Errata Sheet for the MU9C8358 Quad 10/100Mb Ethernet Filter Interface

Pinout Diagram

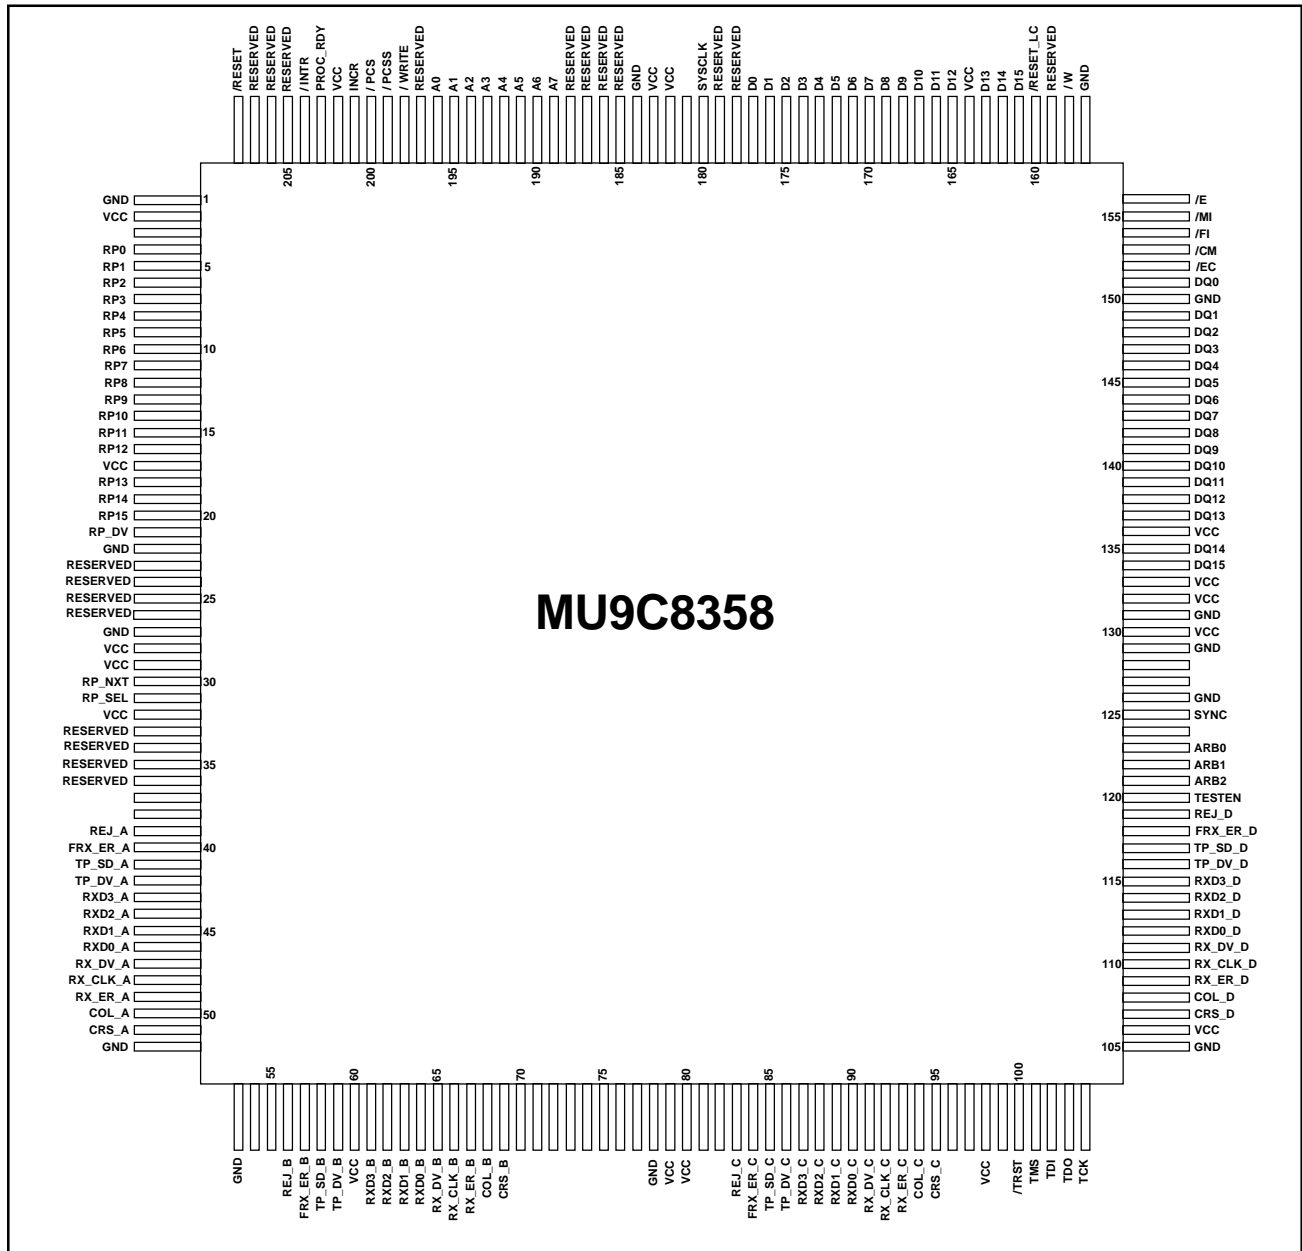
Pin 120 of the MU9C8358 Pinout Diagram was labeled “Reserved,” and is now called “TESTEN.” This pin is used for internal MUSIC Semiconductor testing only and should NOT be left

as “NO CONNECT” in system applications, but must have a pull-up resistor to VCC (typically 10K Ohm). All other reserved pins should be “NO CONNECT” in design applications.
